Item ID: D350-588-011 Accept *N900040100* Setup Start *NS1*
 Revision ID: Stop *NS2*
 Item Name: Aft Door Fwd Hinge Modification
 Start Date: 1/9/2017 Start Qty: 5.00 *5* Cust Item ID:
 Required Date: 1/17/2017 Req'd Qty: 5.00 *5* Customer:
 Reference: DAS 21

DART SERVICE INSTRUCTION

TO AMEND INSTALLATION INSTRUCTIONS D350-588 REV. D AND
INSTRUCTIONS FOR CONTINUED AIRWORTHINESS ICA-D350-588 REV. D
REF TCCA STC SH92-41
FAA STC SH1012NE

A	NEW ISSUE	ML	14.03.24
REV.	DESCRIPTION	BY	DATE
DESIGN	ML	DART AEROSPACE LTD HAWKESBURY, ONTARIO, CANADA	
DRAWN	ML		
CHECKED	<i>[Signature]</i>	DRAWING NO.	REV. A
MFG. APPR.	N/A	DSI 9690	SHEET 1 OF 2
APPROVED	<i>[Signature]</i>	TITLE	SCALE
DE APPR.	<i>[Signature]</i>	STRIKER PLATE MOD	NTS
DATE	14.03.24	COPYRIGHT © 2014 BY DART AEROSPACE LTD THIS DOCUMENT IS PRIVATE AND CONFIDENTIAL AND IS SUPPLIED ON THE EXPRESS CONDITION THAT IT IS NOT TO BE USED FOR ANY PURPOSE OR COPIED OR COMMUNICATED TO ANY OTHER PERSON WITHOUT WRITTEN PERMISSION FROM DART AEROSPACE LTD.

Figure 1 Striker Plate

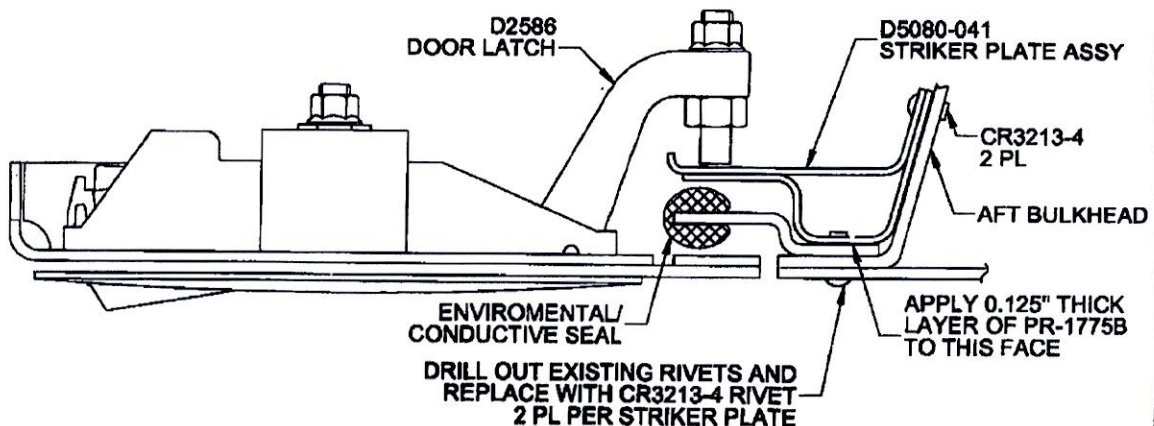
The purpose of this Dart Service Instruction is to provide customers with directions to install a modified striker plate that will provide more clearance around environmental/conductive seals that protrude inboard of the door frame structure on AS355 N/NP models.

- 5) Align D5080-041 striker plate assembly in the previously marked location and transfer drill the $\varnothing 0.1285"$ (#30) holes into the aft bulkhead.

- 8) Deburr holes and remove all sharp edges.
- 9) Touch up all holes in aluminum with chemical conversion coating in accordance with MIL-DTL-5541.
- 10) Apply 0.125" thick layer of PR-1775B ProSeal to the face of D5080-041 per Figure 1.

- 11) Install D5080-041 striker plate assemblies to the aft bulkhead using CR3213-4 rivets of a suitable length, and to the skin of the aircraft using PR-1775B coated CR3213-4 rivets of a suitable length.
